LINDSTRAND HOT AIR BALLOONS LTD

SERVICE INSTRUCTION NO. 5

Issue 1, Dated 3 August 2011

Title: 3 panel rotation vents inspection advice
Classification: Advisory
Applicability: Lindstrand A and C type envelopes 105 and larger
Compliance Standard: Achieve During Next annual / 100 hour Inspection.

Figure 1

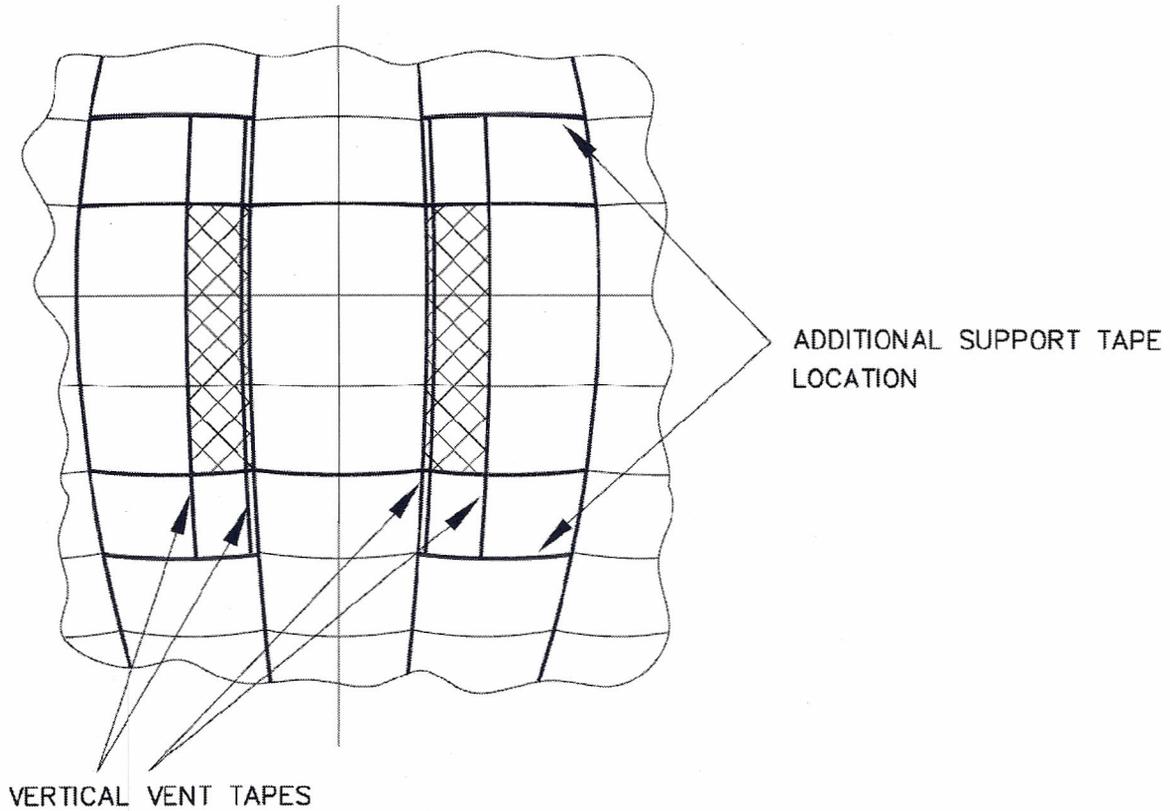
During our continuous monitoring of the performance of our balloons we have noted a number of examples of the external turn vent flap load tapes causing excessive stress in the panel above where it terminates, in envelopes over 400hours or more.

Inspect the fabric in the panel above the turn vents especially close to the end of the load tape which is positioned on the outer edge of the external vent flap. Look for signs of fabric stress and or pulling apart of the fabric

If stress or damage is detected it is recommended that a strengthening tape is sewn across the horizontal seam. So that it extends between the two vertical tapes

The tensile strength of the tape should be 1040kg or greater (medium weight tape).

The sewing method is the standard method described in our maintenance manual.
